Planning Commission
Radnor Township
Wayne, Delaware County, Pennsylvania

Agenda

RE: 205 Strafford Avenue
Preliminary/Final Subdivision Plan
Review No. 2
RETTEW Project No. 101442006

Gannett Fleming, Inc. has completed a review of the 205 Strafford Avenue Preliminary Land Development Plans for compliance with the Radnor Township Code.

SHEET
2
OF 12

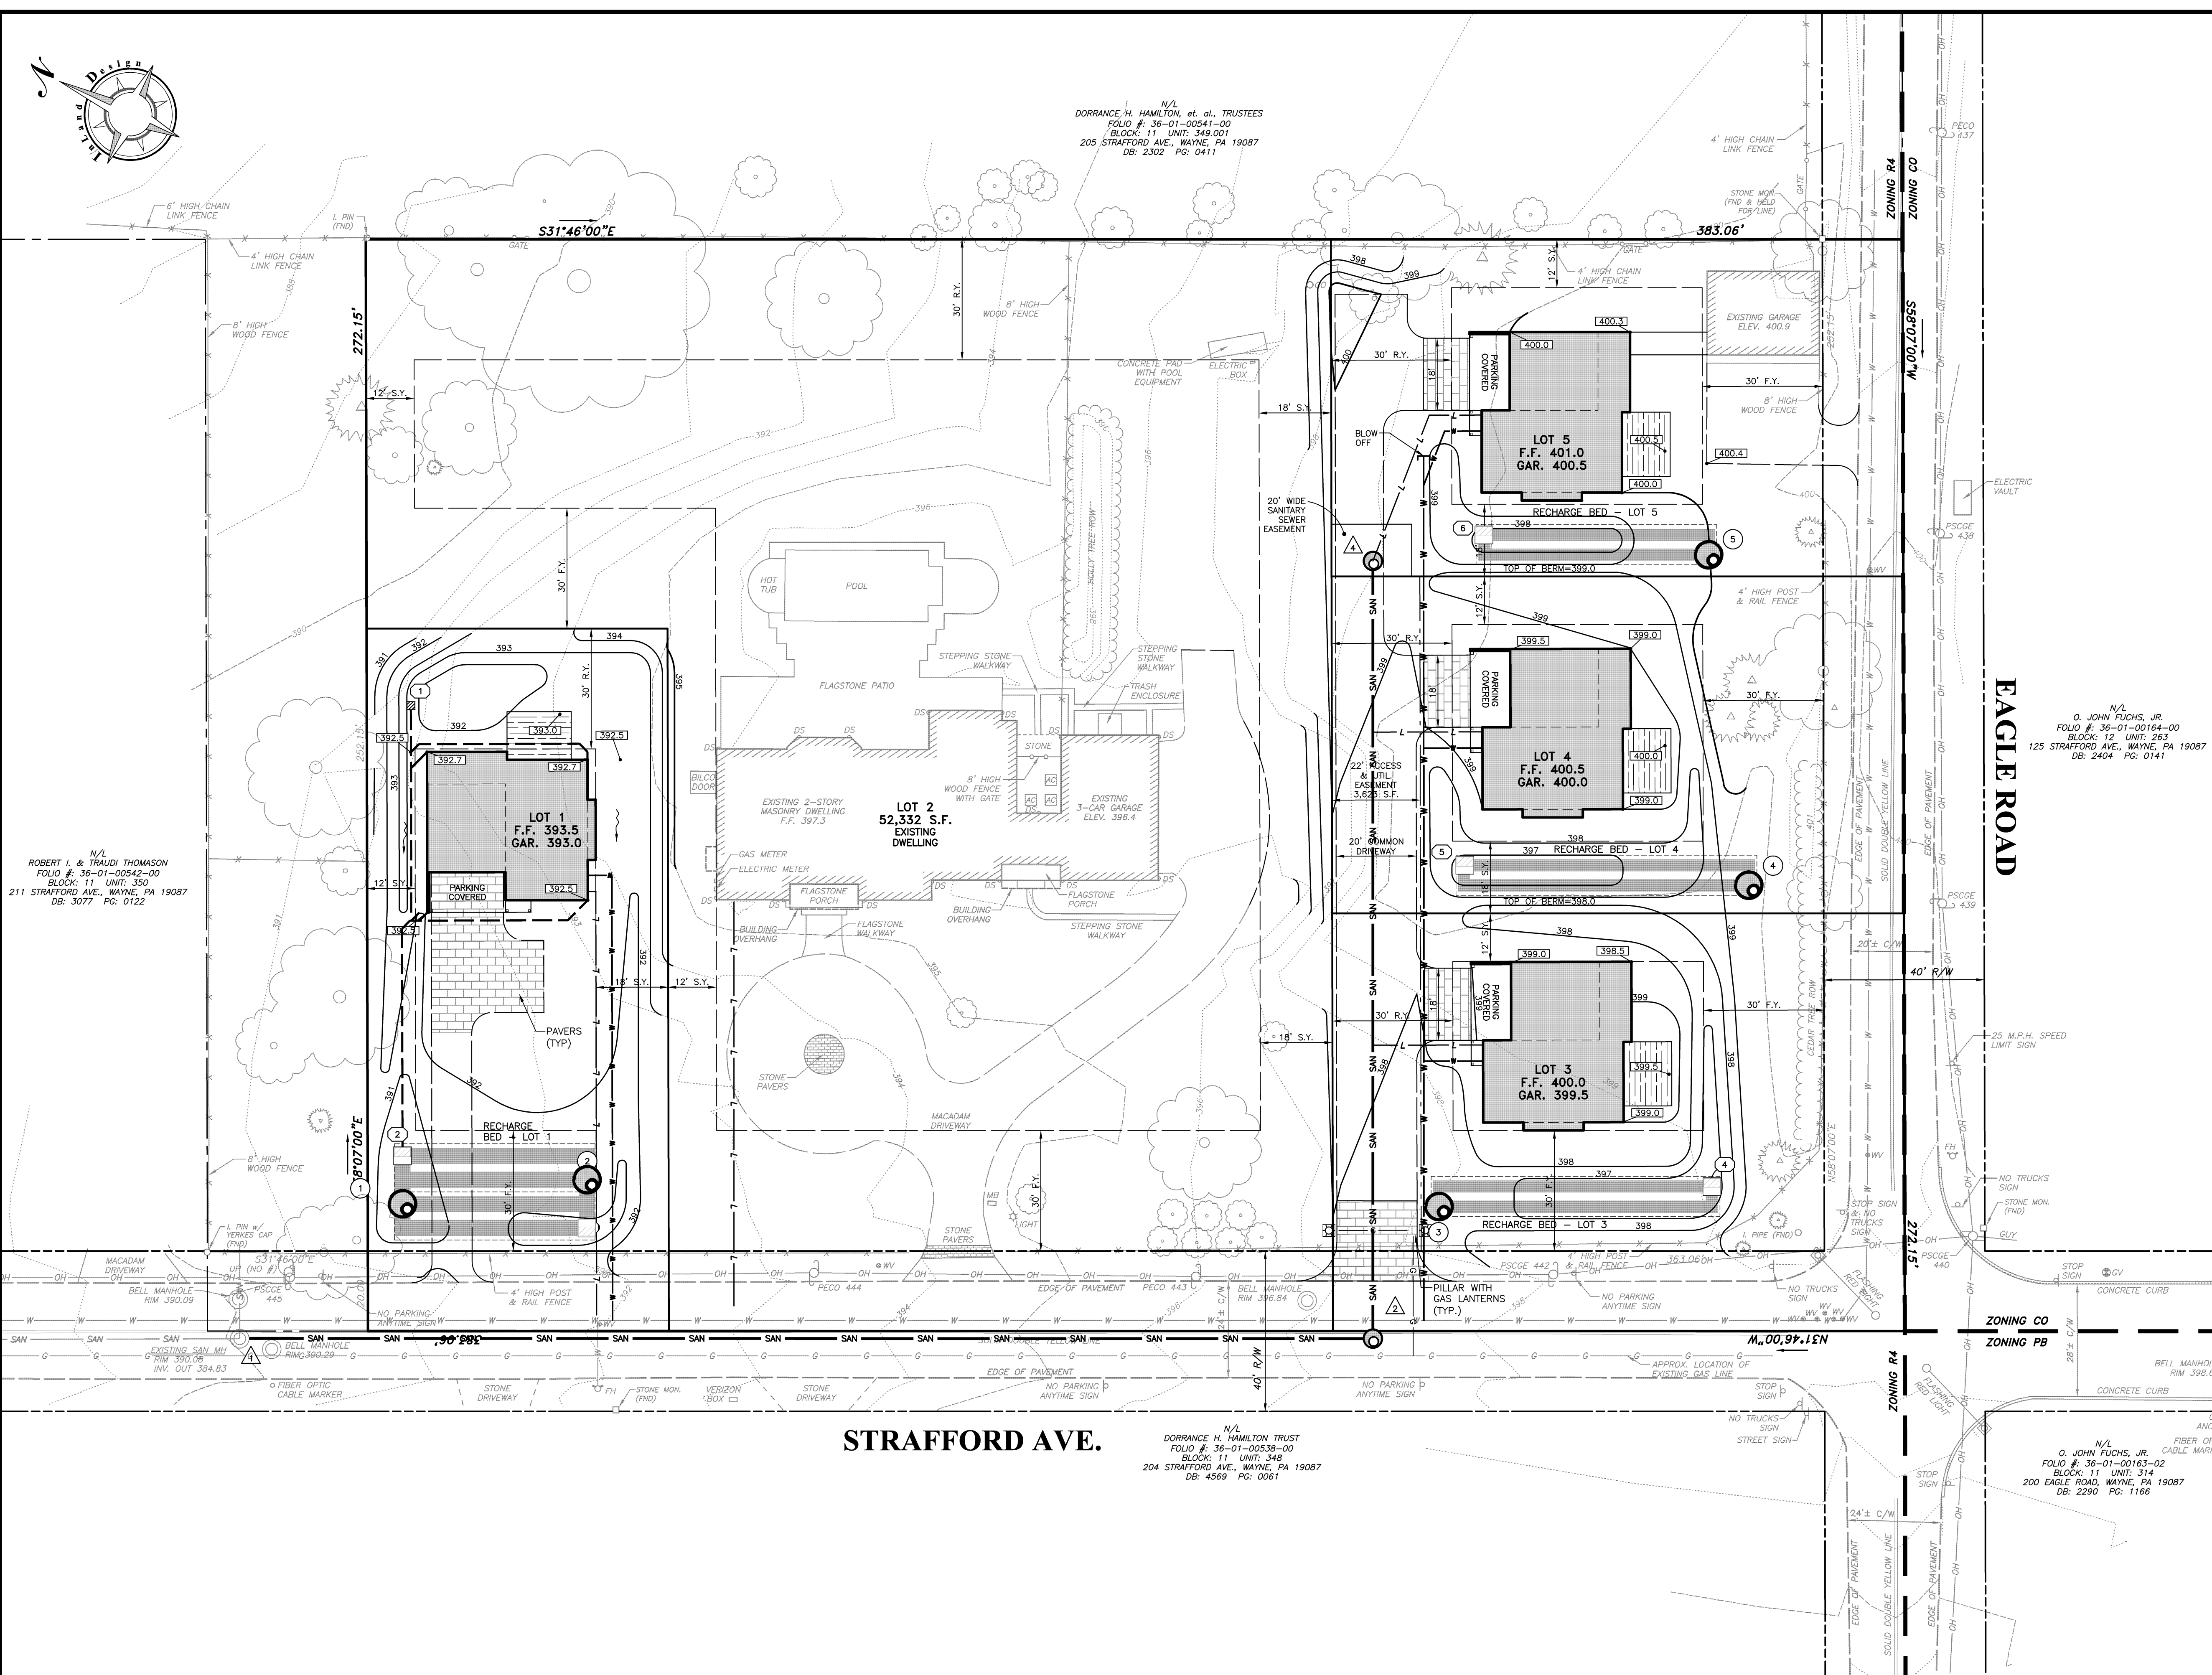
2. It appears that the proposed impervious coverage of 43.2% for Lot 6 shown on the cover sheet exceeds the maximum allowed in the R-4 Residential zoning district of 40% and will require a variance.

1. The zoning table provided on sheet 2 is inconsistent with what is shown on the plans. This must be revised to be consistent. For example, the table indicates that the existing lot 3 will have a front yard setback of 85 feet and a rear yard setback of 117 feet. The front and rear yard setbacks dimensioned on the plans is 30 feet.

1. The referenced setbacks noted on the zoning table were measured from the existing building. The zoning table has been revised to reflect the requirement of the R-4 Zoning District as requested.
2. 280-4.B Interior Lot– The referenced lot has been removed from the plan.
3. 280-4.B Interior Lot Development – The referenced lot has been removed from the plan.
4. 280-30.F – The coverage for the referenced lot has been adjusted to comply with zoning.
